Re: Resource Recovery and Protection Plan (R2P2) modification for the Crandall Canyon
Logical Mining Unit Application U-80659

The Bureau of Land Management (BLM) received your R2P2 modification for the Crandall Canyon Logical Mining Unit application on February 19, 2009 (See Attachment 1). We find the following deficiencies in your submittal.

Attachment 2: Approved LMU R2P2 (North Crandall Only), 23 February 2005

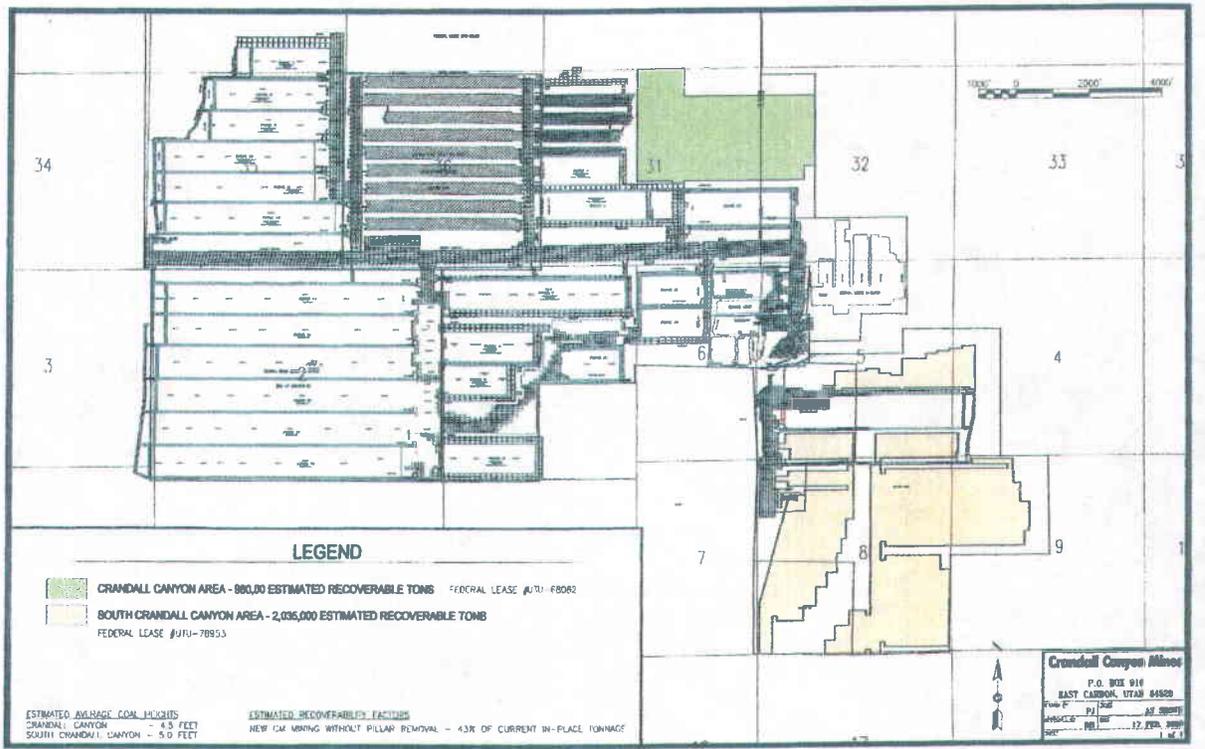
1. The map that the information is presented is not-up-to date.
2. The timing must be shown on the map for the area to be mined. This should be by month and year.
3. The previous approved R2P2 dated February 23, 2005 (See Attachment 2) shows mining the pillars in the main entries. 43 CFR 3482.2 (c)(2), states in part, that the operator shall submit a written statement along with a justification for the change. The previous plan that was approved by BLM showed the mining of the main pillars. BLM cannot approve a plan that does not meet Maximum Economic Recovery (43 CFR 3482.2(2)).
